Officer Assessment Report

PA2504026 – 9 Hagelthorn
Street, Wonthaggi

Key Information	Details						
Application No:	PA2504026						
Received:	28 October 2025						
Applicant:	Housing Choices Australia C-/Tract						
Planning Scheme:	Bass Coast						
Land Address:	9 Hagelthorn Street, Wonthaggi						
Development Value:	\$12.7 million						
Why is the Minister responsible?	In accordance with Clause 72.01-1 of the Planning Scheme, the Minister for Planning is the responsible Authority for this application because the Minister for Planning is the responsible authority for matters under Divisions 1, 1A, 2 and 3 of Part 4 of the Act, and endorsement of, approval of or being satisfied with matters required by a permit or the scheme to be endorsed, approved or done to the satisfaction of the responsible authority, in relation to the use and development of land for a development to which clause 53.23 applies.						
Why is a permit required?	<table border="1"><thead><tr><th>Clause</th><th>Control</th><th>Trigger</th></tr></thead><tbody><tr><td>Clause 32.08</td><td>General Residential Zone Schedule 3 (GRZ3)</td><td>Clause 32.08-7 – construct two or more dwellings on a lot</td></tr></tbody></

Figure 6 – Typical east-west section through the site showing the non-compliance with the rear (southern) boundary.

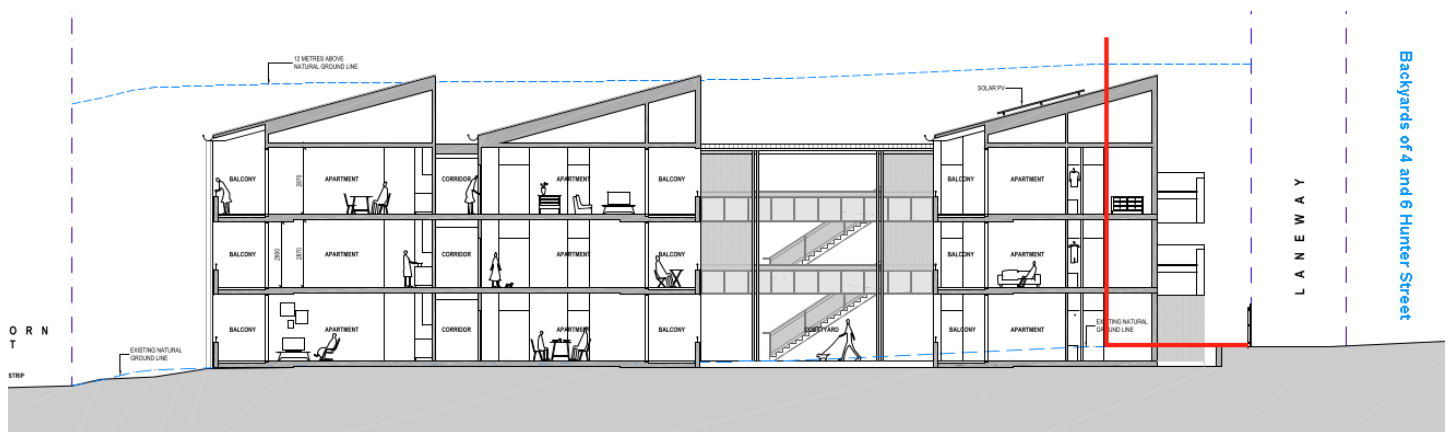
53. The building is setback 2-4m from the southern (rear) boundary and does not comply with either standard B2-3.1 or B2-3.2. However, a variation is supported for the following reasons:

- The reduced rear setback enables a minimum 9m internal separation between the balustrades of the balconies between inward facing dwellings, avoiding the need to screen these balconies. This provides an enhanced amenity outcome for future residents.

- Given that the site adjoins a 4.5m wide laneway the subject site and the rear boundary of dwellings that face onto Hunter Street, it provides an additional buffer between properties, which will further ameliorate any unreasonable visual impacts.

- The submitted shadow diagrams demonstrate that, despite the reduced setback, there are no unreasonable additional overshadowing neighbouring properties. Refer to below assessment.

Figure 7 - Extract of overlooking diagrams

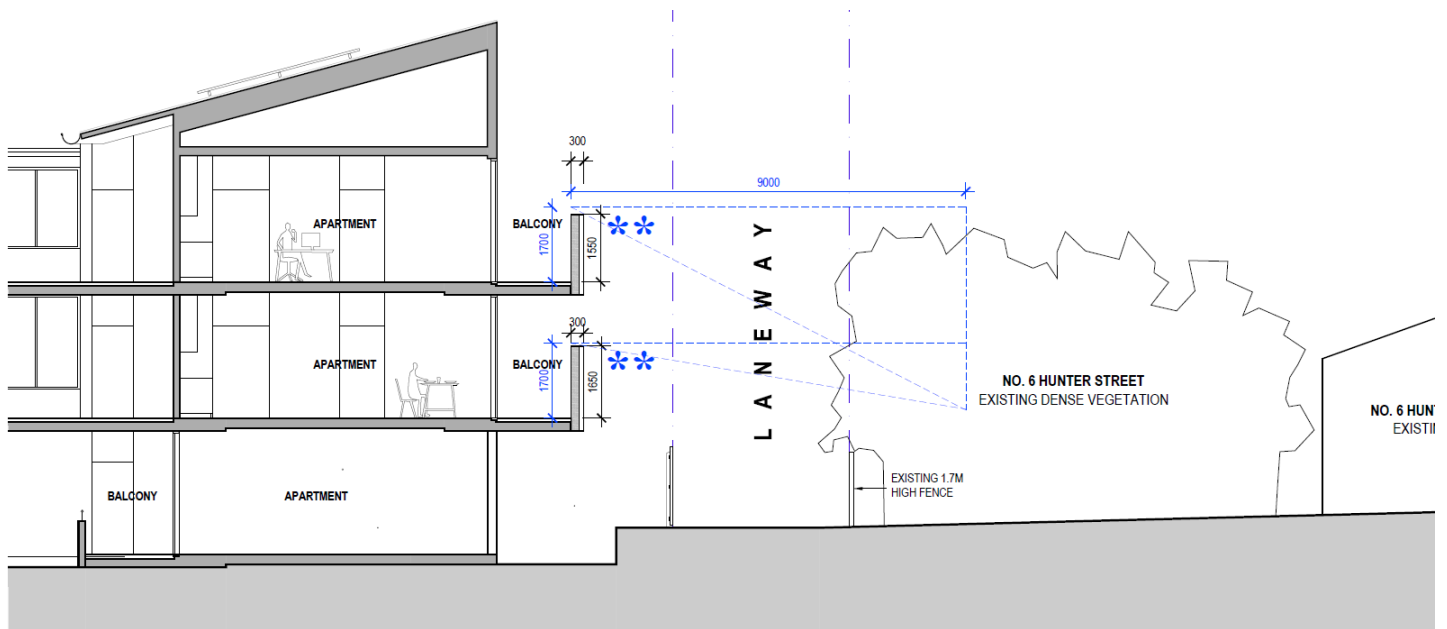
58. The submitted plans show that there are habitable windows located on the adjoining property at 7 Hagelthorn Street within 9 metres from proposed habitable room windows and new balconies associated with the development.

- At ground floor, there is no opportunity for overlooking into 7 Hagelthorn Street, given that the area is a car park.
- At the first and second floor, there are proposed kitchen windows that face onto this property's habitable room windows, resulting in potential direct views in a downward direction, where within 9 metres. As such, it will be a condition of permit requiring that these kitchen windows be obscured to 1.7m to preclude overlooking.

59. The submitted plans shown that there are proposed balconies located within 9 metres from the SPOS of 4 and 6 Hunter Street.

- At ground floor, there are no opportunities for overlooking into that space.
- At the first floor, the balconies have 1.65m high balustrades with a 300mm shelf, acting as a privacy screen. This will appropriately obstruct direct horizontal and downward views to the SPOS of 4 and 6 Hunter Street.
- Similarly at the second floor, the balconies have 1.55m high balustrades with a 300mm shelf acting as privacy screens. This will sufficiently obstruct direct horizontal and downward views.

60. As such, the proposal will avoid unreasonable overlooking, subject to conditions.

Figure 8 - Extract from the UCR of a conceptual diagram showing how the design of the building has been derived

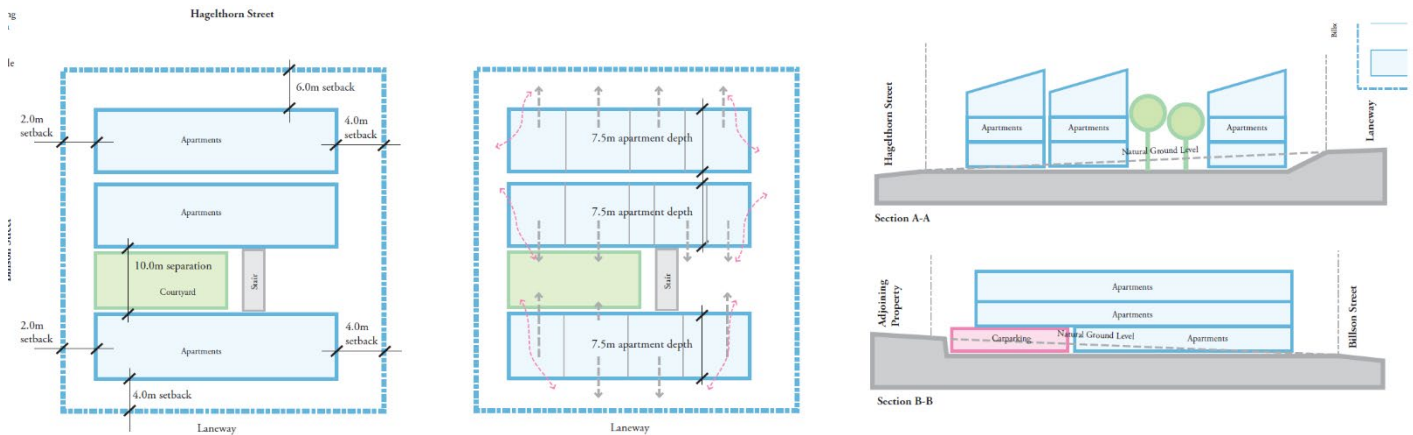
62. The UCR is satisfactory and has demonstrated that the proposal achieves a high degree of detailed design noting that:

- The overall massing has been setback from its relevant boundaries to create a graduated built form in the streetscape corner, and responds directly to the immediate interfaces to preclude off-site amenity impacts.

- The design includes a vertical break within the central built form to separate and break up the volume and massing. This provides a meaningful design entrance, creates articulation in the built form and a communal open space area.

- The facades are further 'divided' into small sections using a series of 'building breaks' to provide a relief in built form, while being respectful of the existing rhythm and spacing

- The chosen material is combination of masonry and metal cladding, which appropriately balances neighbourhood character while providing a contemporary built form.

- The undercroft car parking has been sensitivity integrated within the overall design ensuring that the car parking structure is appropriately screened from the public realm.

63. The architectural response is considered acceptable.

Figure 9 - Extract from the landscape concept plan showing the proposed landscape features

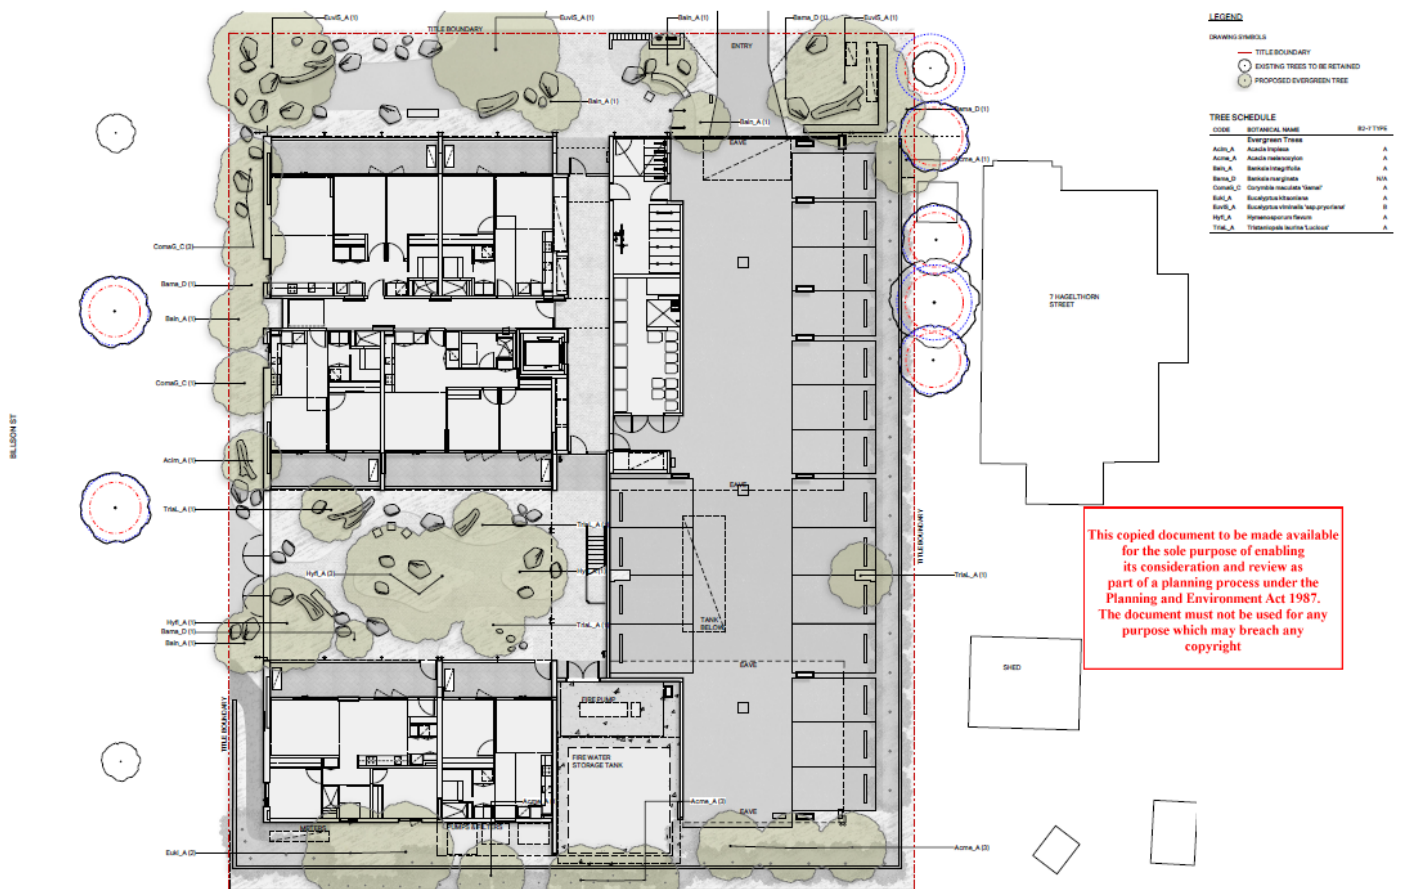
- The frontage will provide a combination of new canopy trees, grass and low level shrubs, replacing the removed low value vegetation currently on site. These elements are considered appropriate and conducive towards creating a 'front garden' character that prevails within this part of Wonthaggi.
- The side setback to Billson Street will be a combination of grass and hard paving.

- The proposal avoids unreasonable impacts to the neighbouring trees (14, 15, 16, 17 and 18) located at 7 Hagelthorn Street.
 - Along the eastern boundary, there is a proposed retaining wall. Though, this retaining wall is setback between 0.6-1m from the neighbouring trees 14, 15 and 16. This is consistent with the recommendations of the arborist report and is sufficient to avoid any impacts to the SRZs of those trees
 - The design results in no impact to neighbouring trees 17 and 18.
- A new communal open space which incorporates paving and feature rocks ensuring a high a degree of future amenity for residents.

66. Overall, the proposal will provide an acceptable degree of landscaping.
